STAFF REPORT
COMMUNITY DEVELOPMENT DEPARTMENT

SUBJECT: H-2020-0092
Goddard Creek Community

LOCATION: Northwest corner of W. McMillan Rd.
and N. Goddard Creek Way.

EXTERIOR ELEVATIONS
A4.0

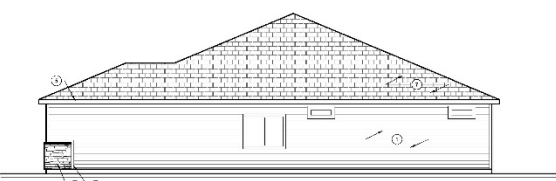
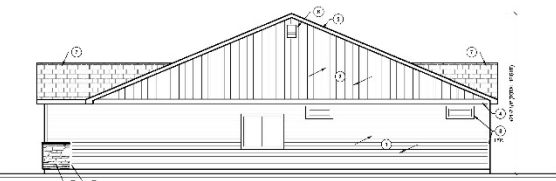
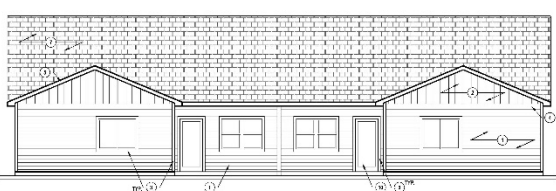
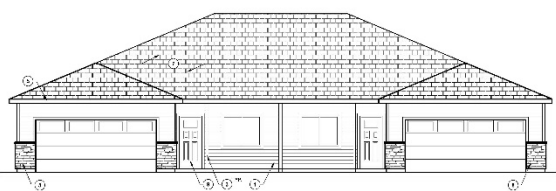
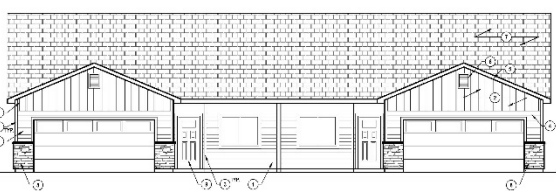
The design of structures on this site is required to comply with the design standards listed in UDC 11-3A-19 and the City of Meridian Architectural Standards Manual because they are an attached product with two or more dwelling units. The development should incorporate high quality architectural design and materials that is also consistent with the MU-C designation. Conceptual building elevations are proposed as shown for the single-family attached units.

All structures within the development are required to comply with the residential design standards listed in the Architectural Standards Manual. An administrative design review application must be submitted to the Planning Division and approved prior to submittal of building permit applications; one design review application may be submitted for the overall development.

- a. Parking issues that persist within adjacent apartment complex;
- b. Concern over the proposed elevations that face towards the public right-of-way.

- a. Future development of this site shall comply with the preliminary plat, landscape plan, and conceptual building elevations (single-story) included in Section VII and the provisions contained herein.

11. All structures within the development are required to comply with the residential design standards listed in the Architectural Standards Manual. An administrative design review application shall be submitted to the Planning Division and approved prior to submittal of building permit applications; one design review application may be submitted for the overall development.
